23 July 2025

Ref: L.30257.002

Yumba-Meta Oonoona (Lot 5000 on SP302846)
Application Reference: DEV-2026-OBA-4730
Response to Information Request- Flooding

Figure 1 Flood Levels and Depths, 1% AEP Event, Current Planning Scheme

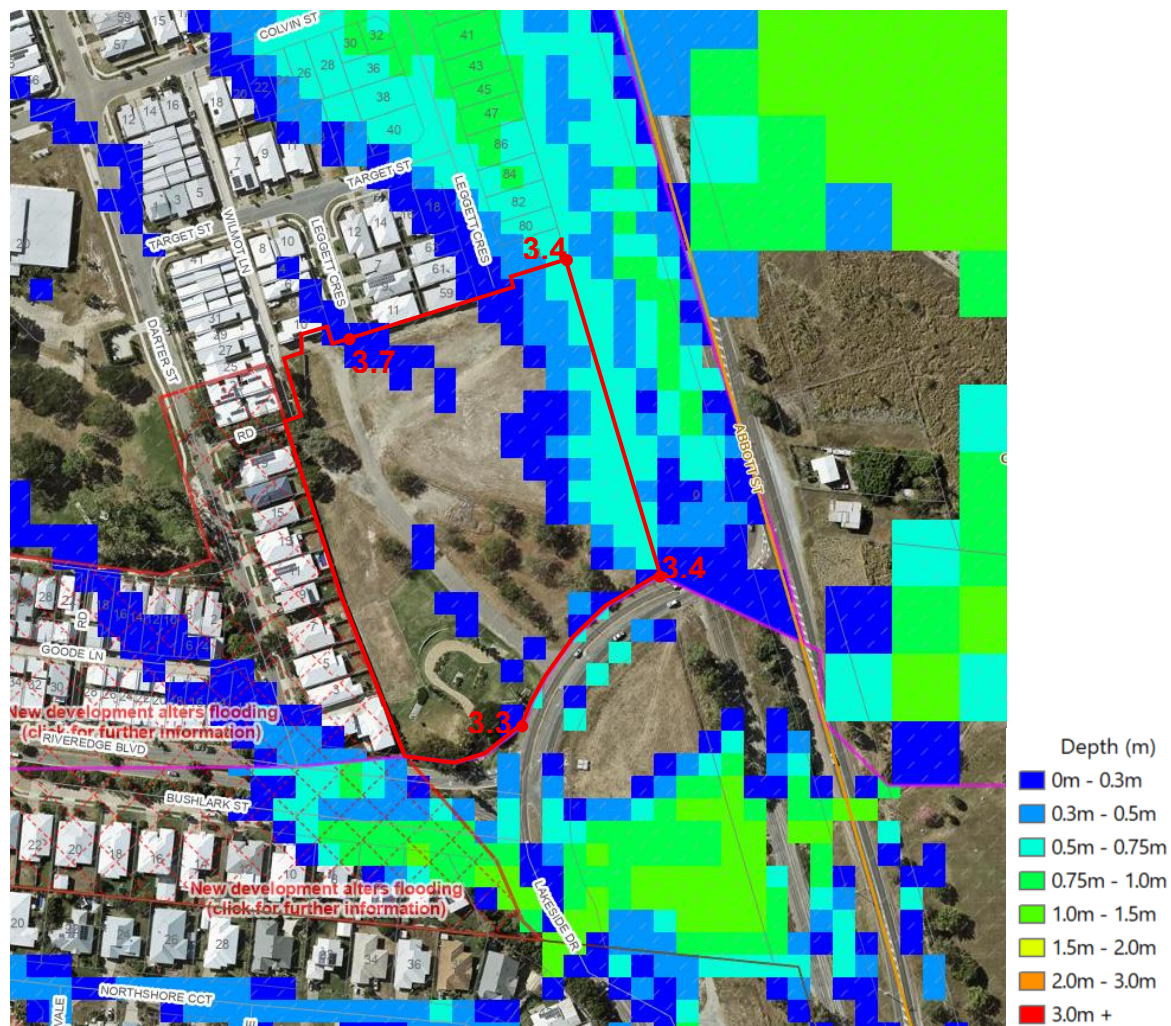
6. Demonstrate that flood storage loss and floor levels comply with the Townsville City Plan flood overlay code.'

It is understood that the current Council flood mapping is based on the previous flood study of the Ross River, as reported in the Ross River Flood Study, Base-line Flooding Assessment (Aecom, January 2013, the **2013 Ross River Flood Study**). Due to its age, the flood modelling captured conditions prior to the current development of the Onoonba area.

The flood mapping, flood levels and flood depths based on the 2013 Ross River Flood Study are presented in Figure 1.

A similar conclusion is drawn in relation to the 3.7 mAHD level nominated at the northern site boundary on Figure 1 from the 2013 Ross River Flood Study.
